# IMPORTANT INFORMATION!

## MUST READ BEFORE ASSEMBLY – NEW PARTS ATTACHED TO BOX

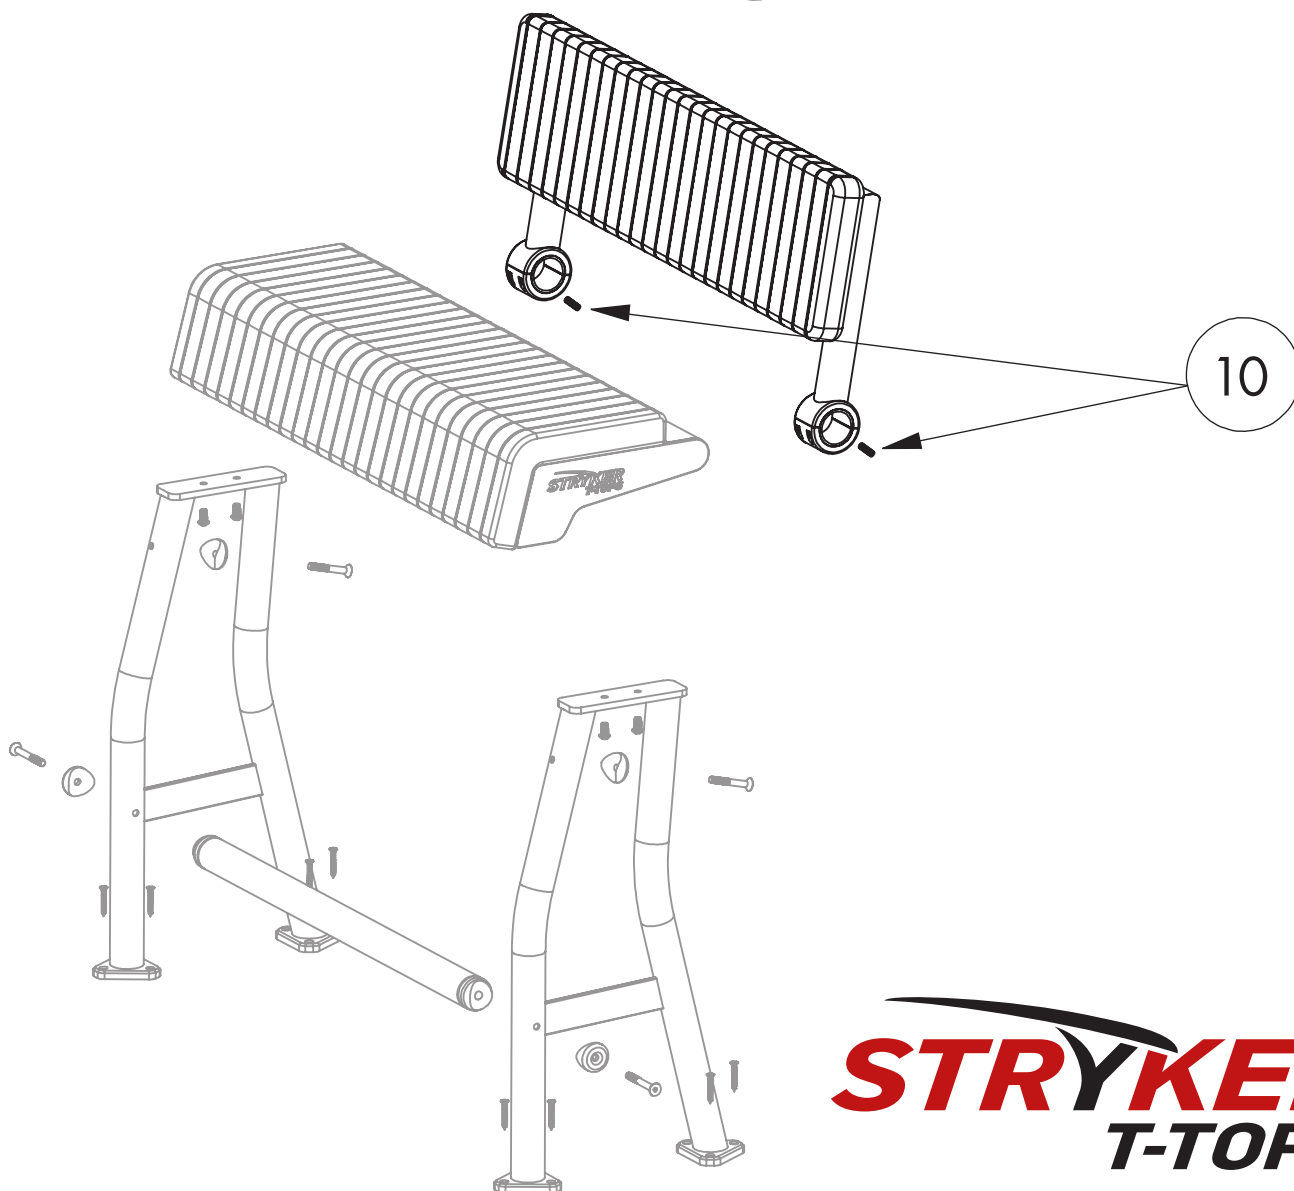
New set screws have been provided with all Stryker LP100 leaning posts. These set screws are used for securing the back rest clamps to a desired position. Attached to the outside of the shipping box is a packet with two **pointed tip set screws** that are to be used instead of the flat tip set screws currently installed in the clamps. **Please discard the incorrect flat tip set screws.** Refer to part #10 in the schematic below which can be downloaded from [strykertops.com/installation-guides](http://strykertops.com/installation-guides).

### NEW POINTED TIP SET SCREW

Use these two replacement screws during the installation.

### OLD FLAT TIP SET SCREW

**DO NOT USE!** Discard these two screws immediately.
